Product Change Notification

111176 - 00

Change Notification #:	111176 - 00
Change Title:	Intel PRO/1000 MF Dual Port Server Adapters (Double Eldridge OEM generic/Retail), PRO/1000 PF Server Adapters (Sheepshead Bay OEM generic/Retail) and PRO/1000 PF Dual Port Server Adapters (Bretona OEM generic/Retail) PCN 111176-00 Label OUI block change
Date of Publication:	December 2, 2011

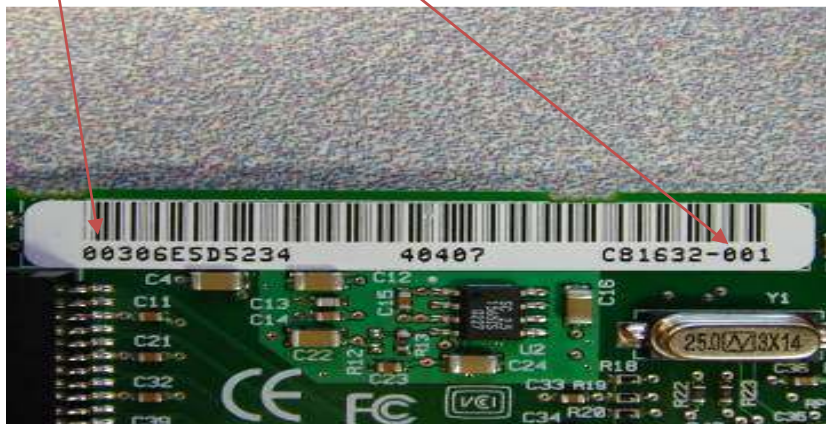
OUI Block change: Past run rates have caused the available blocks of MAC addresses assigned to run out. The OUI Block 00-1B-21 has hit the low water mark, the new OUI Block will be 68-05-CA (Sheepshead Bay, Bretona) and 90-E2-BA (Double Eldridge).

3n1 label change: The 3n1 label will change to reflect the new OUI Block number and PBA# dash roll (printed board assembly), as show in the picture below. The 3n1 label is placed on the Front side of the Printed Board. (picture example only)
